STATE OF FLORIDA DEPARTMENT OF TRANSPORTATION

2010 Interim Design Standard

18" SQUARE PRESTRESSED CONCRETE PILE

Index No. 20618

SECTION A-A

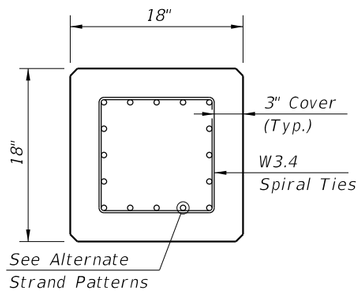
DATE	BY	DESCRIPTION	DATE	BY	DESCRIPTION
07/01/10	GJM	"ALTERNATE STRAND PATTERNS" Added: "16 ~ ½" Ø, Grade 270 LRS, at 26 kips" Changed: 12 ~ 0.6" Ø, Grade 270 LRS, to "35 kips"; 20 ~ 7/16" Ø, Grade 270 LRS, to "21 kips" and 24 ~ ⅜" Ø, Grade 270 LRS, to "17 kips". Deleted: "SR" strand pattern options.

12 ~ 0.6" Ø, Grade 270 LRS, at 35 kips
12 ~ ½" Ø (Spec), Grade 270 LRS, at 34 kips
16 ~ ½" Ø, Grade 270 LRS, at 26 kips
20 ~ 7/16" Ø, Grade 270 LRS, at 21 kips
24 ~ ⅜" Ø, Grade 270 LRS, at 17 kips
